Amendments to the Drawings:

REMARKS/ARGUMENTS

DELETE INDICATED FIG. 1
REFERENCE NUMERALS

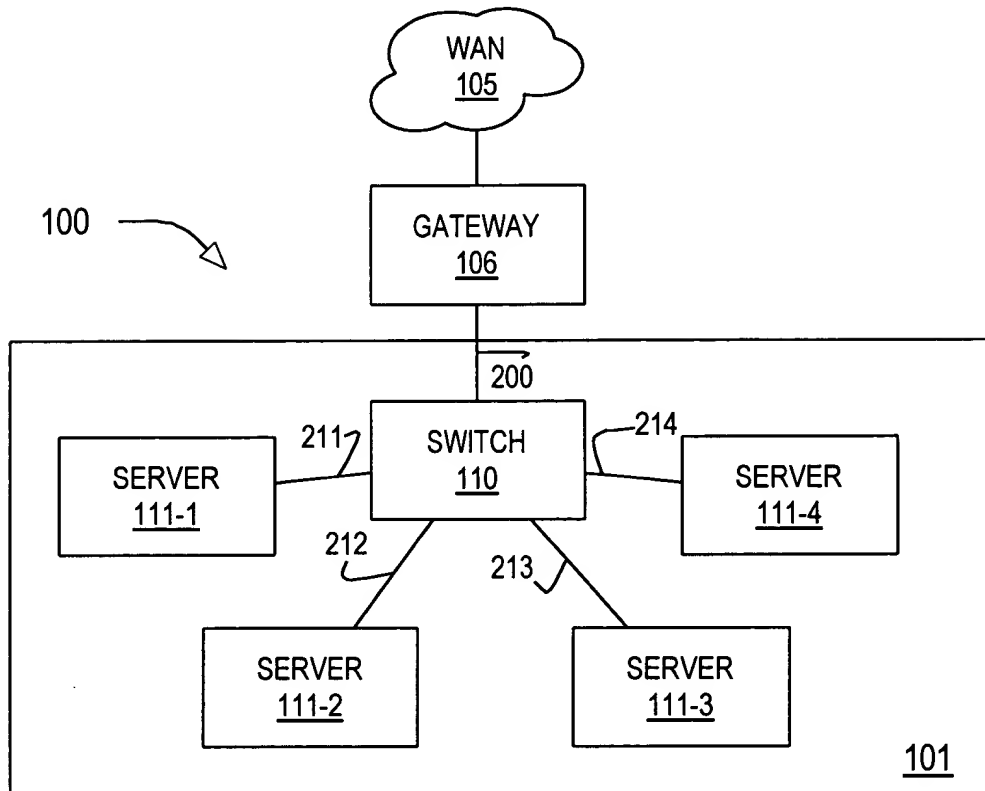
The Examiner objected to originally submitted FIG. 2 because it included reference characters not mentioned in the description. In response, Applicant has submitted a proposed replacement drawing page for sheet 1 of 3 of the originally submitted drawings. The offending reference numerals have been removed from the proposed replacement sheet. No other changes have been made. Applicant respectfully requests the Examiner to accept the proposed drawing sheet and withdraw the objection.

Applicant has submitted with this response a proposed replacement drawing sheet for Sheet 1 of 3 of the originally submitted drawings. Four reference numerals found in the originally submitted drawing sheet have been deleted in the proposed drawing sheet consistent with the Examiner's appropriate determination that the drawings contained reference numerals not found in the specification. No other changes have been made to the drawings.
